RECEIPT DATE: 3/4/19**ONSITE SEWAGE DISPOSAL SYSTEM**P 564773APPROVAL DATE: 3/18/19 SEC**PERMIT: CONSTRUCTION**

PROPERTY ADDRESS: 15208 Torino WaySUBDIVISION: Fairlane FarmsLOT: 29

**MEMORANDUM**

**RE: 15208 Torino Way**  
**Fairlane Farms, Lot 29**

PERMIT SITE PLAN  
LOT 29

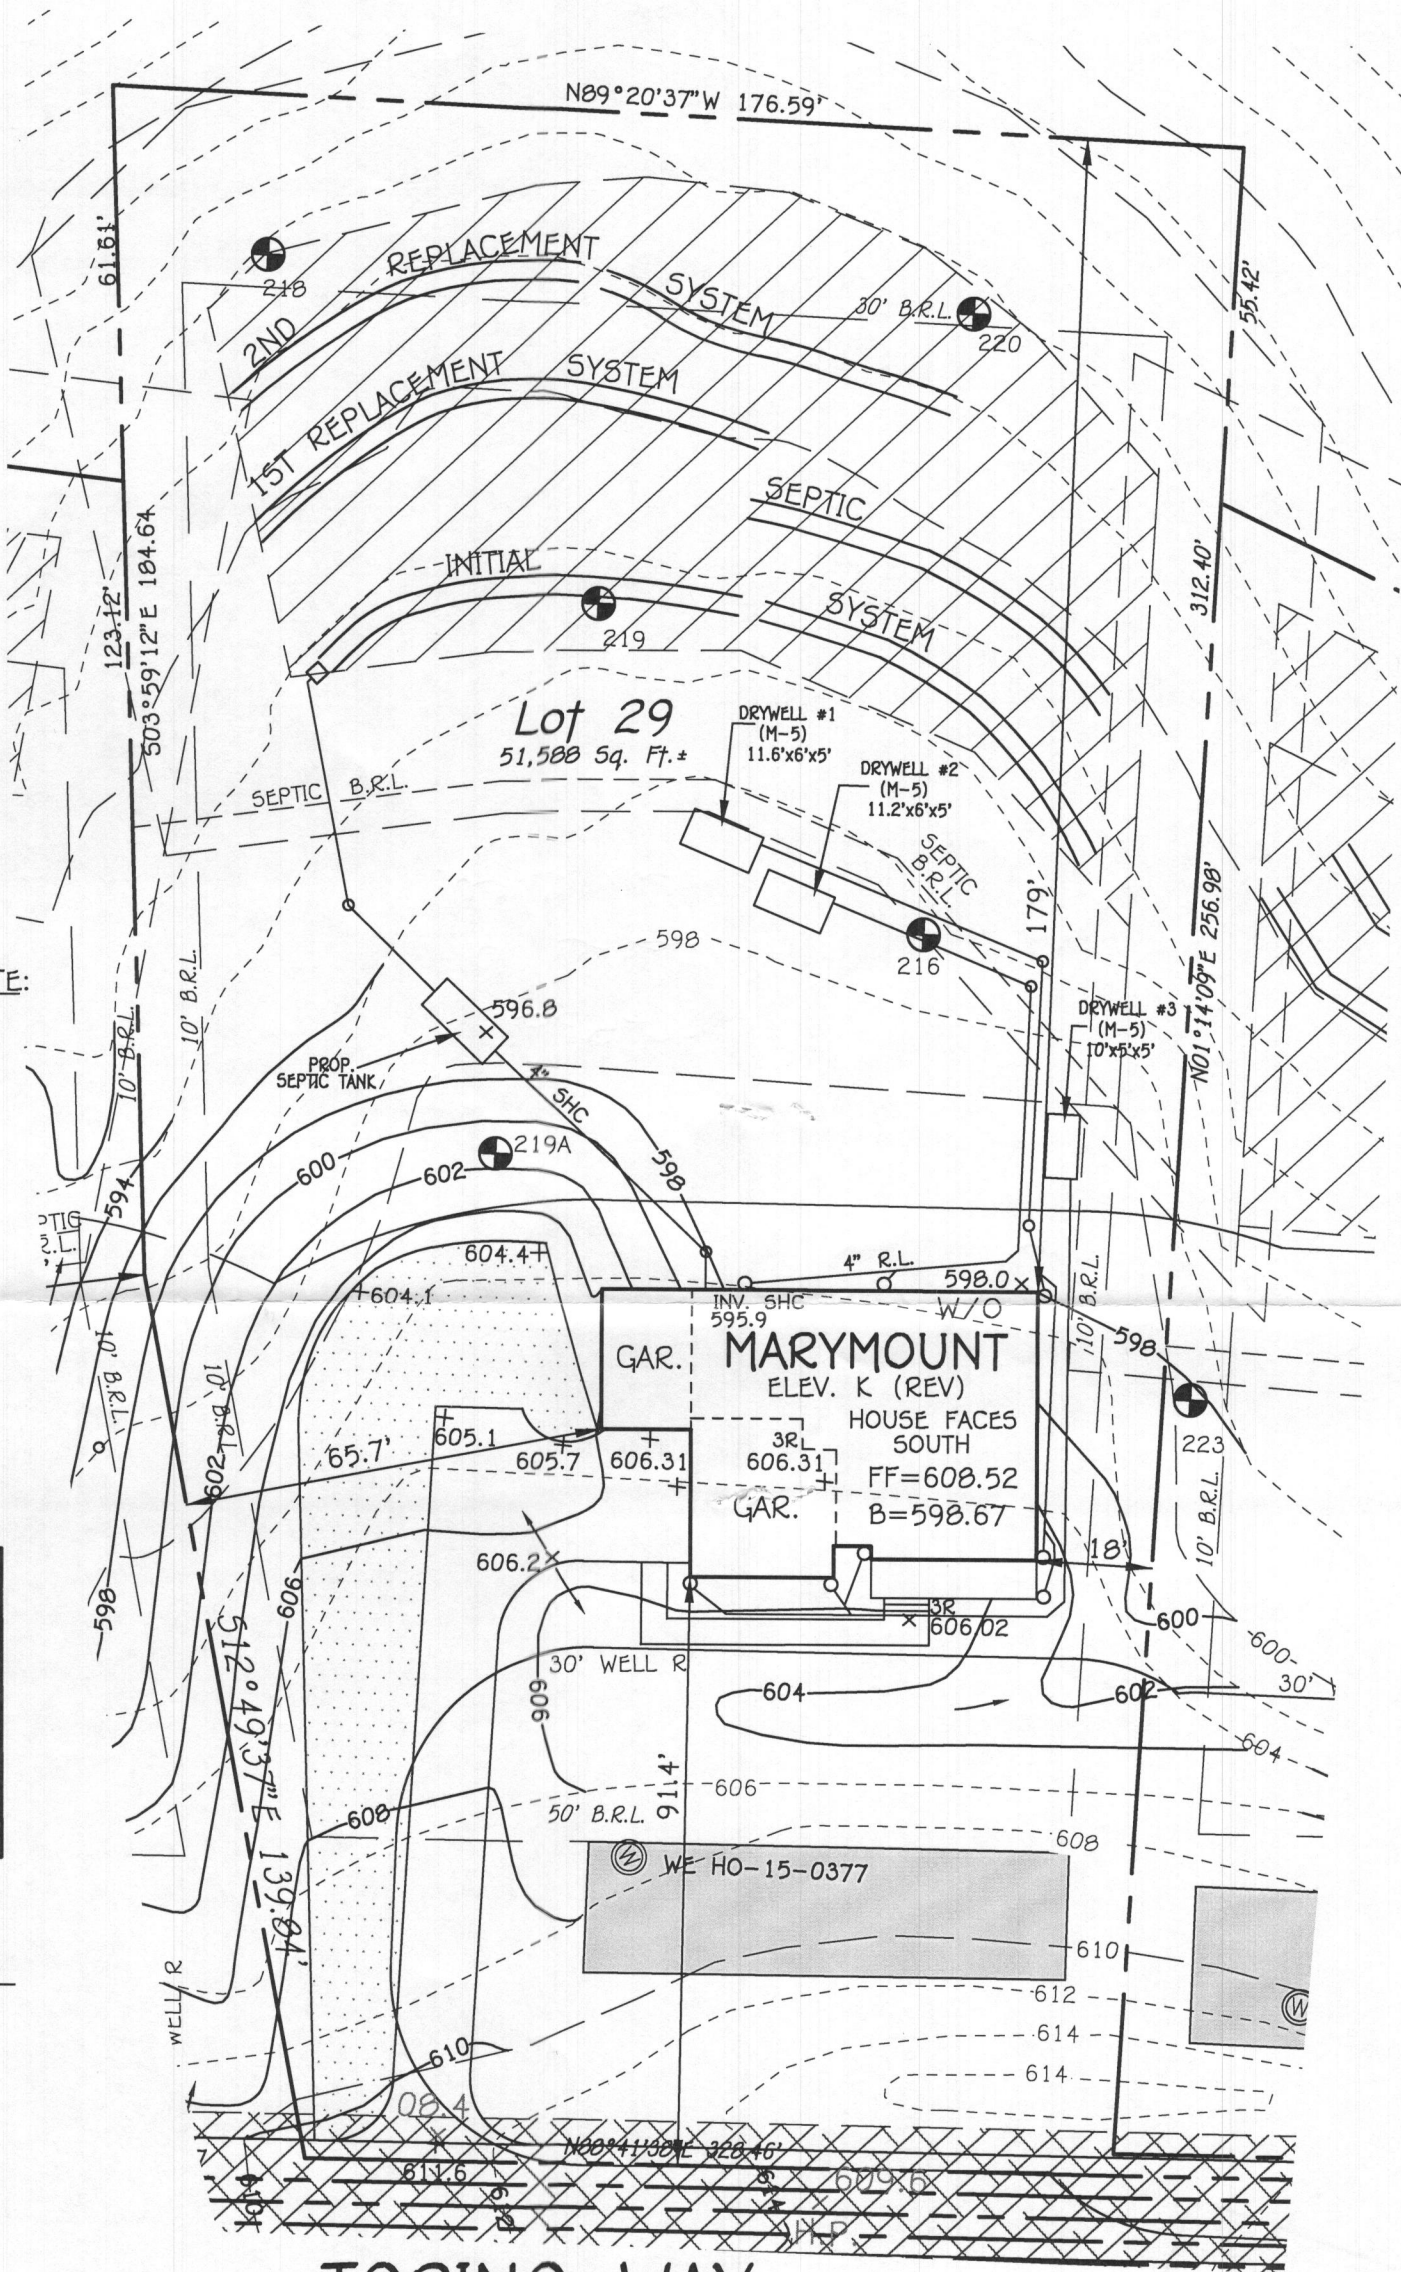
The OSDS Plan has been approved. Please revise the permit plot plan with new elevations near tank to DILP.
